SHOP DRAWING TRANSMITTAL

Project: Turnbull School Music Room Addition Project No: 1705
Date: November 12, 2018
To: TALCO Building Innovations Ltd.
Attn: Farah Bano (fbano@tal-co.com)
From: Michelle Cataldo

Shop Drawing Submittal: 05 41 00 – Structural Metal Studs
Submitted by: VRIEND Engineering
Drawing Title: S1 General Notes & Partial Ground Floor
S2 Wall Sections
S3 Sections & Details
Revision No. 0
Dated: 6/11/18

SHEET TITLE:
 GENERAL NOTES
 & PARTIAL
 GROUND FLOOR

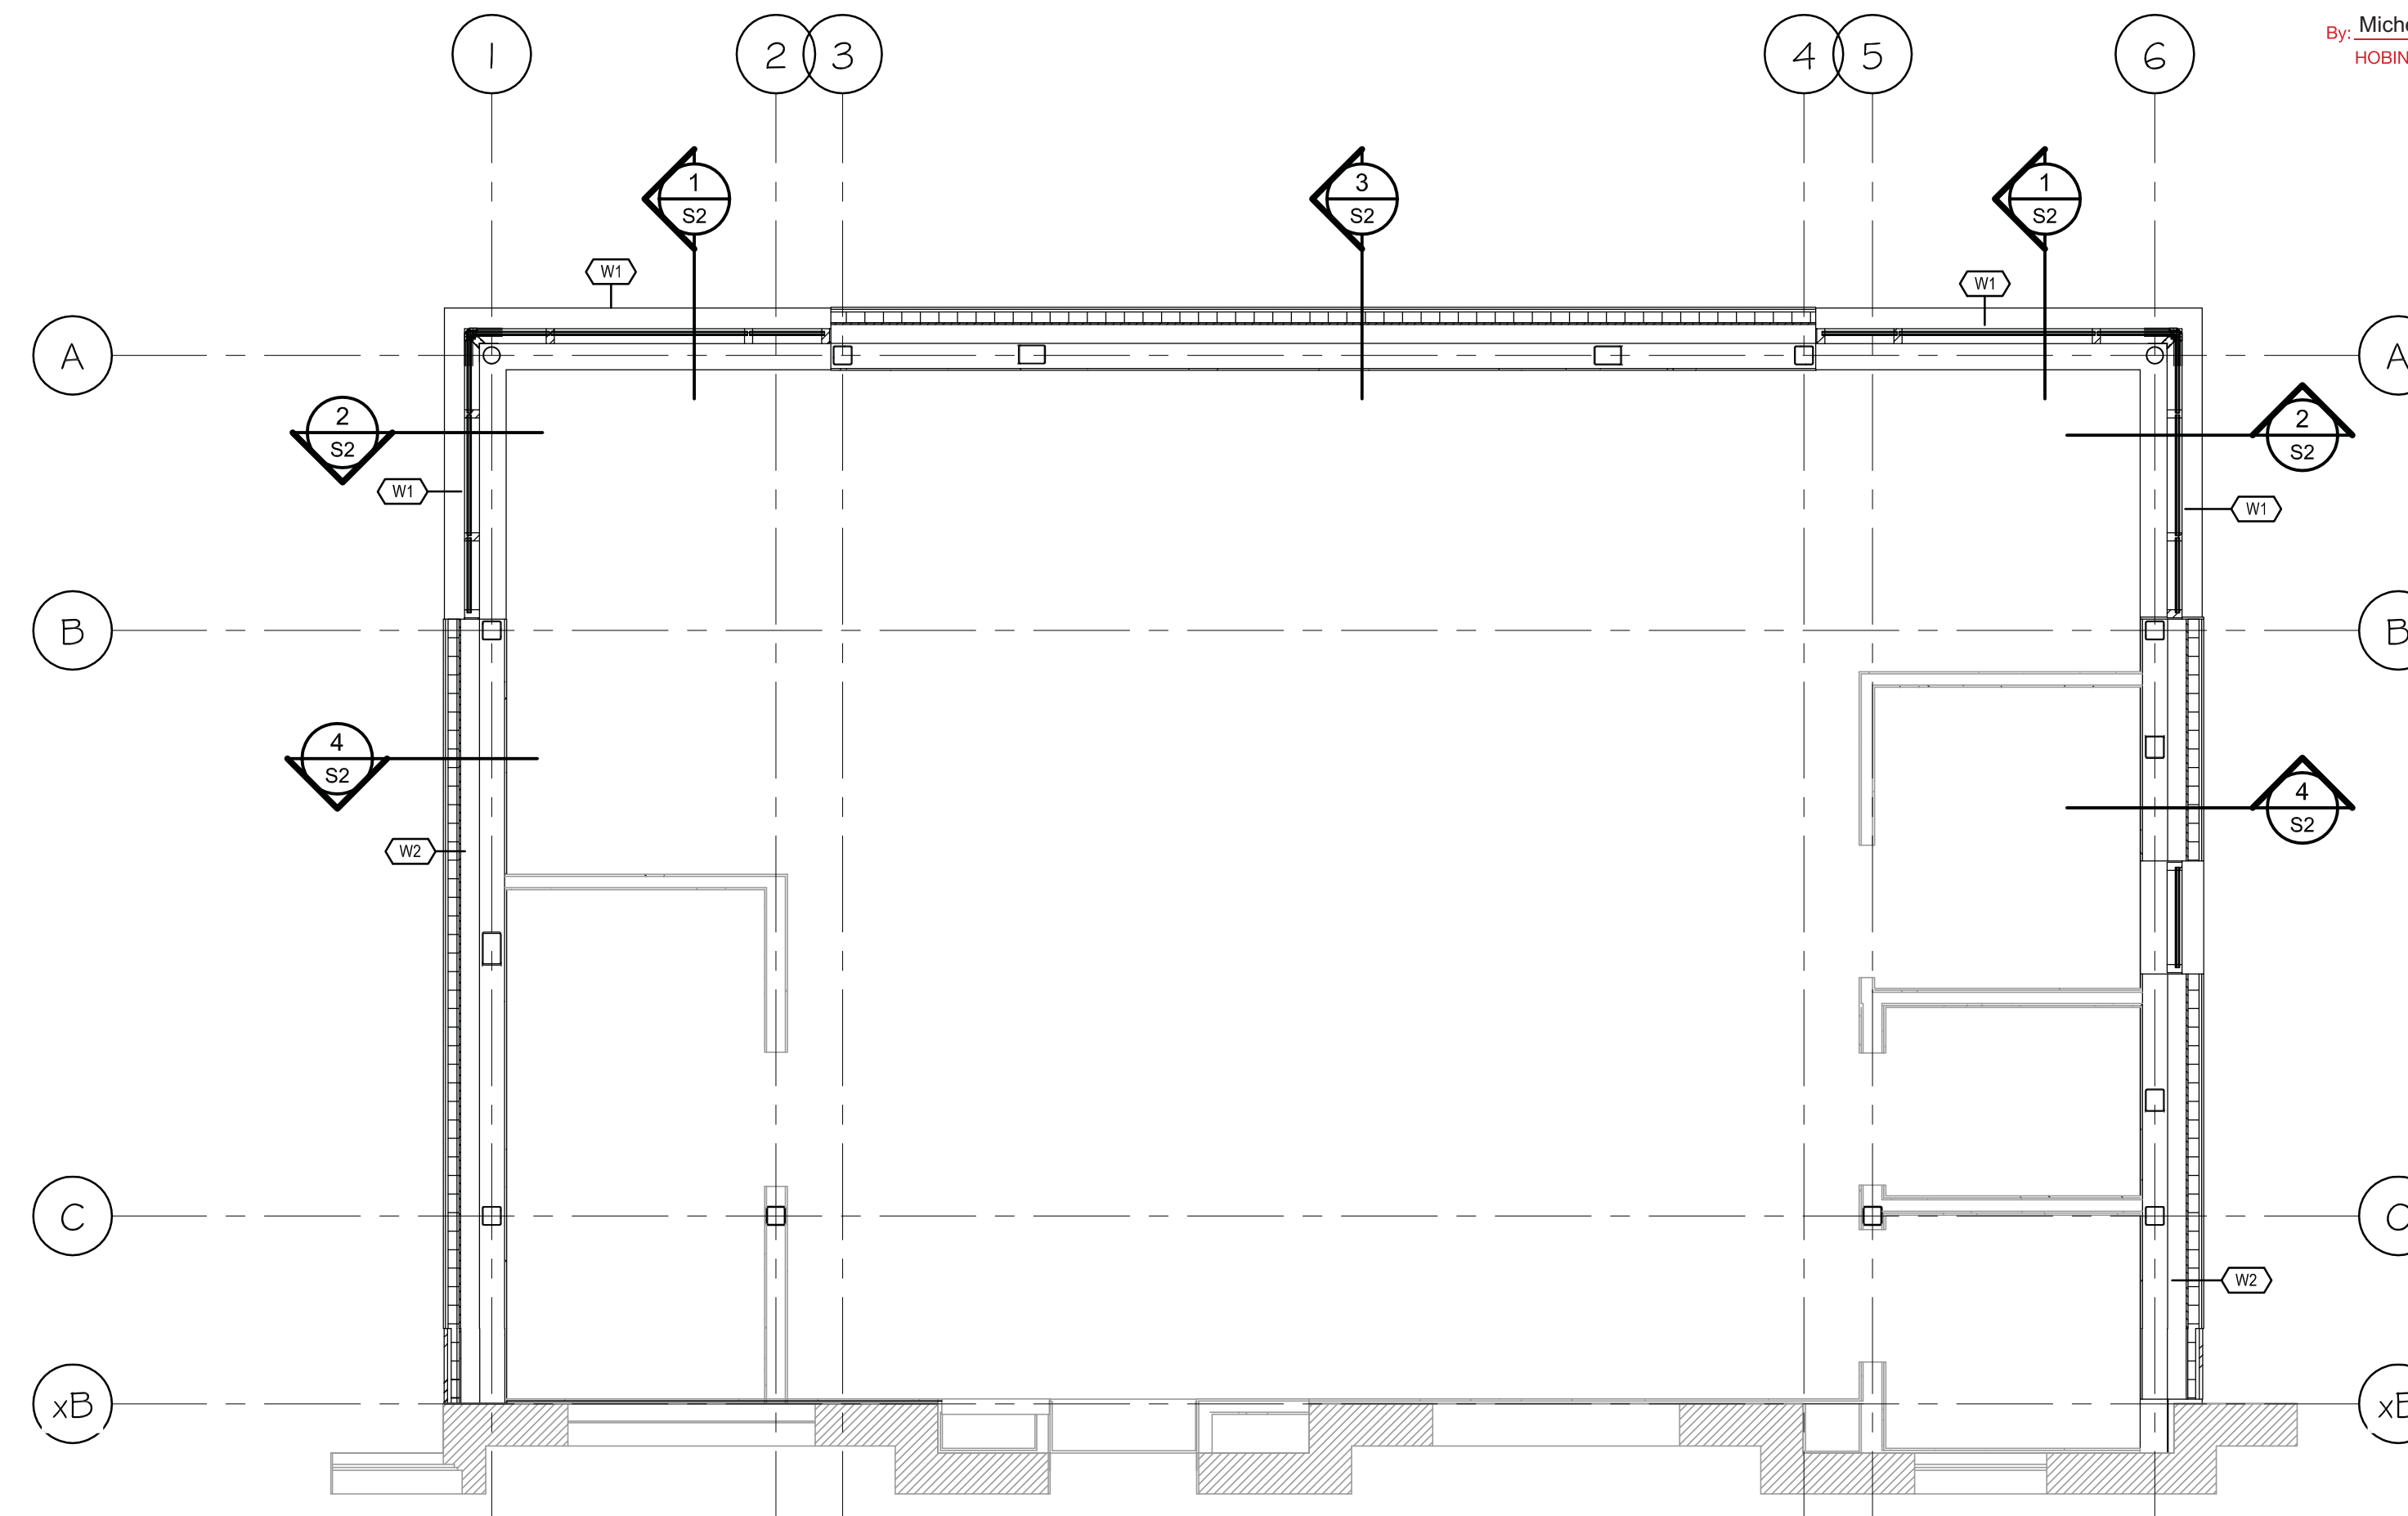
Interior partitions to be 8" x 25 ga (1 1/4" flange). Bridging not required for interior partitions.

SHEET TITLE:
WALL SECTIONS

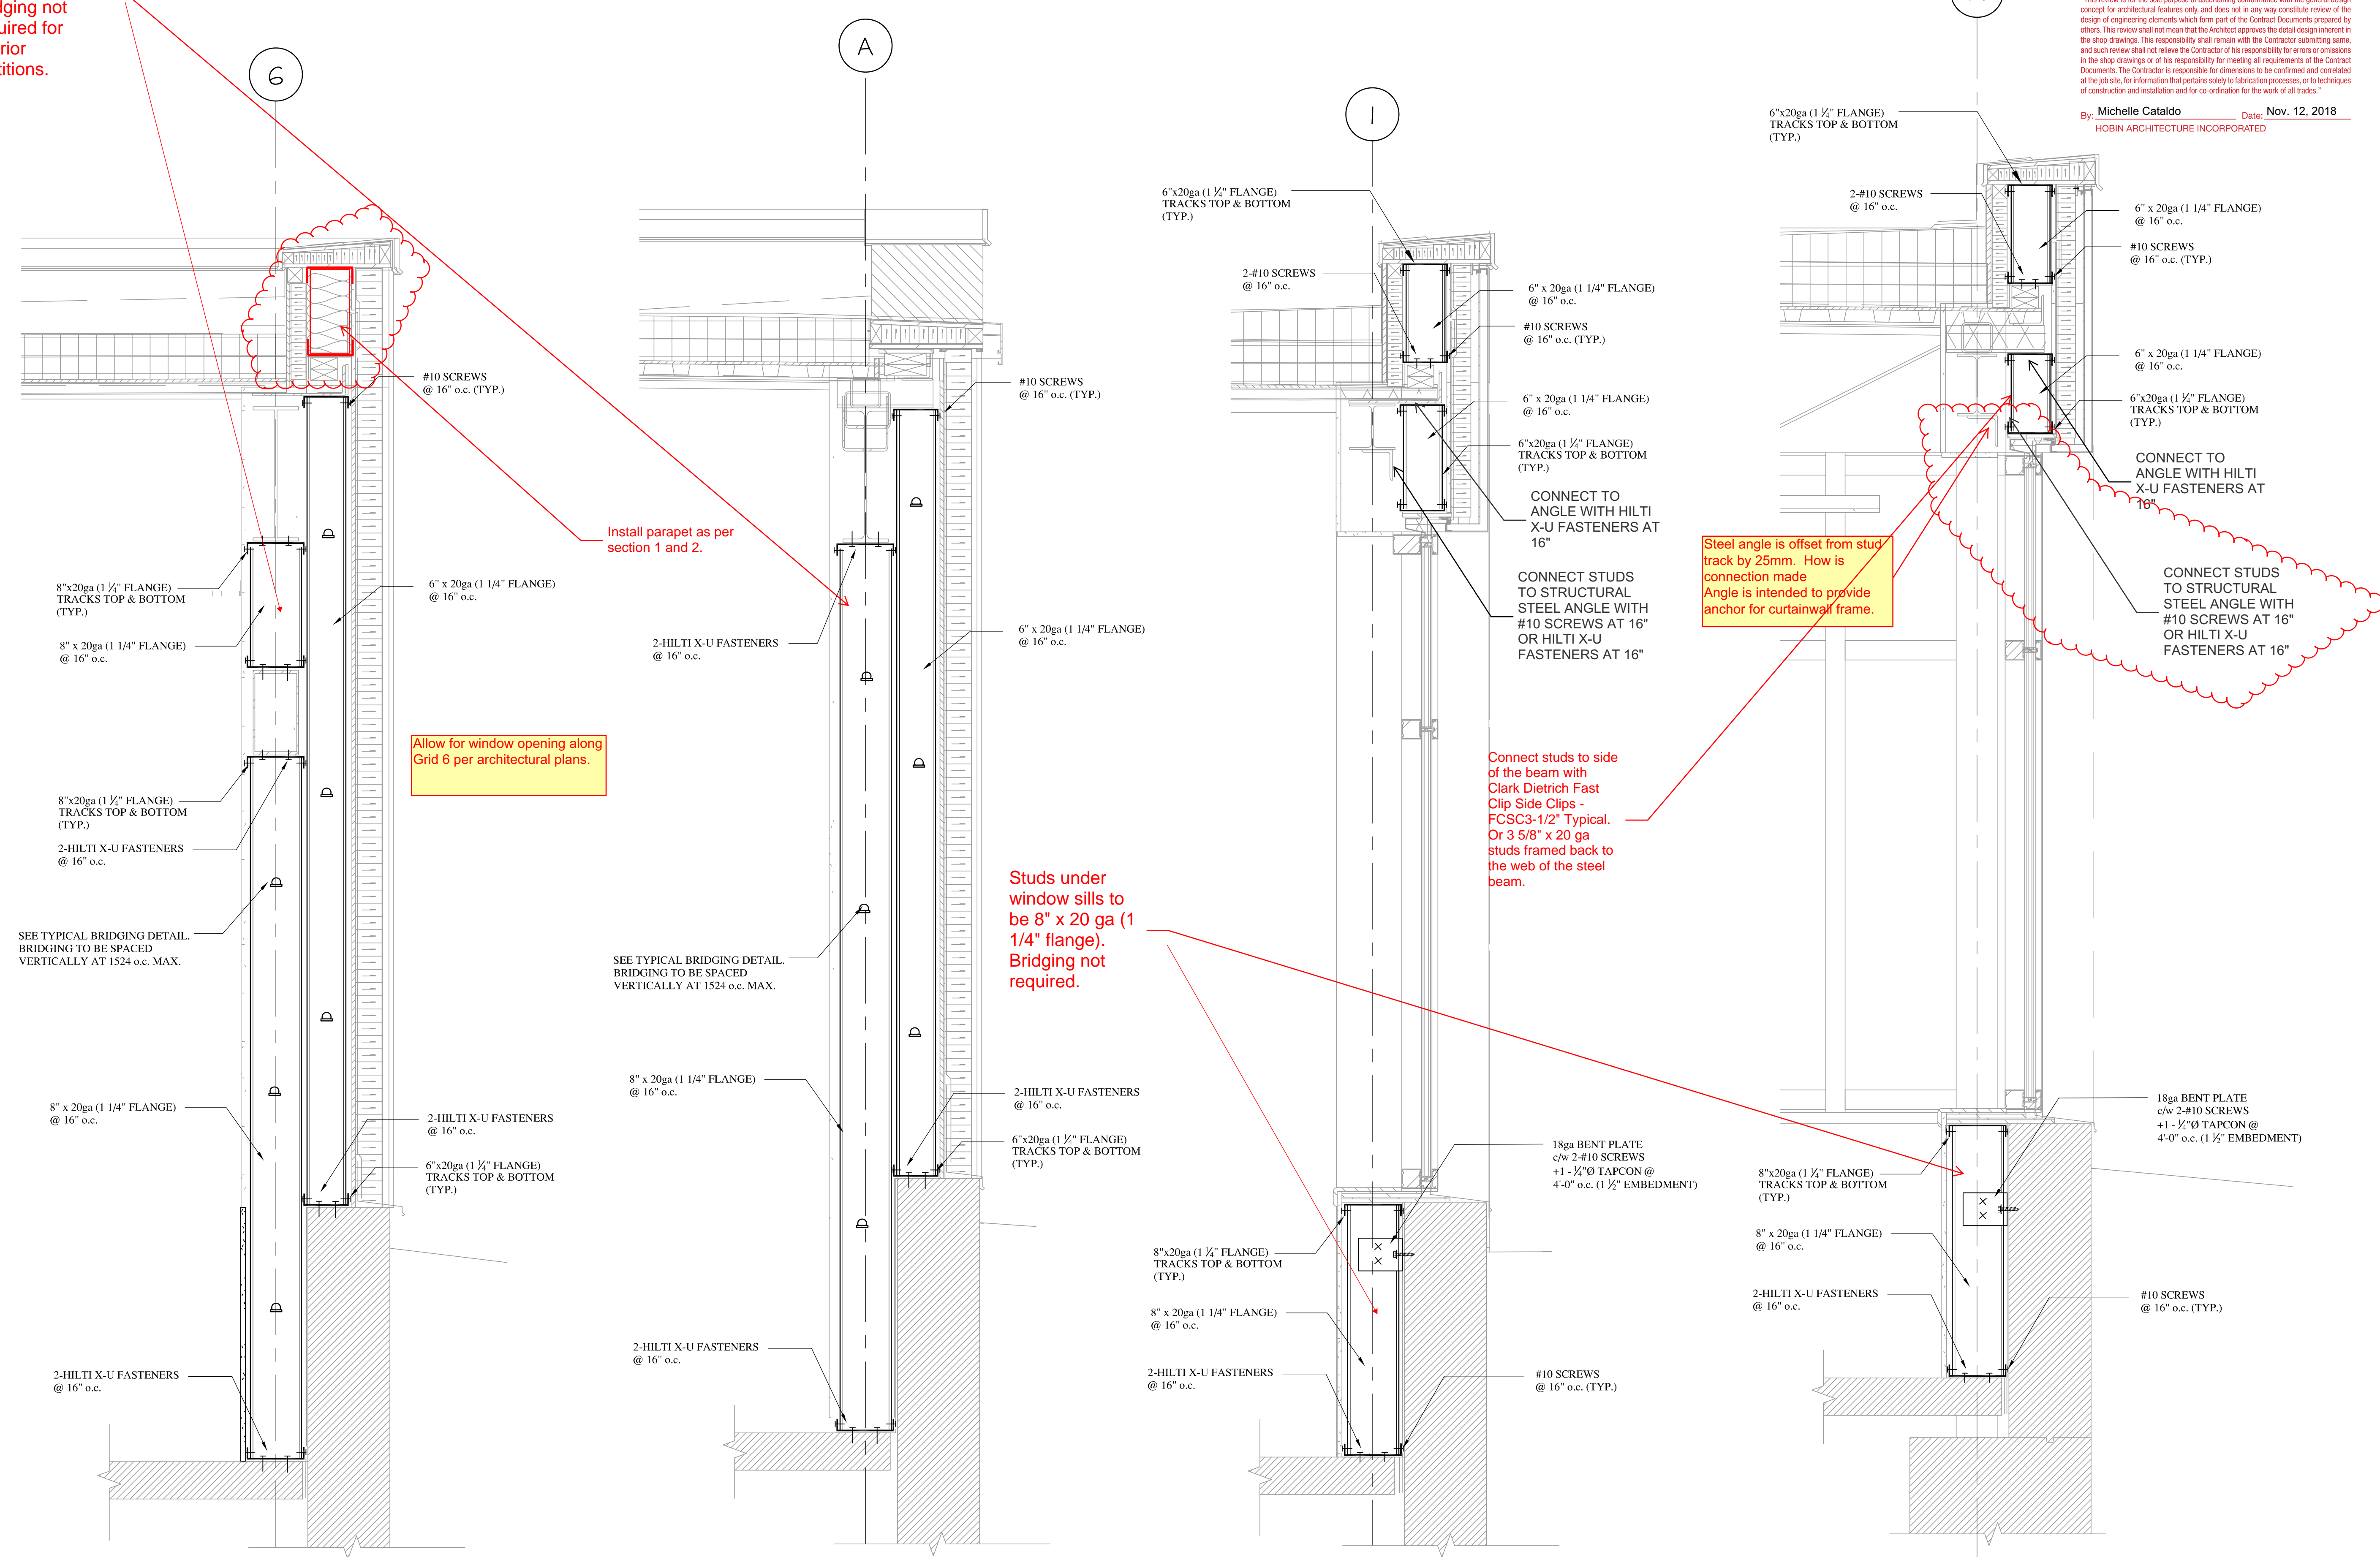
Reviewed as noted. Please make note of the offset of steel angle from stud track by 25mm. Angle is intended to provide anchor for curtainwall frame.
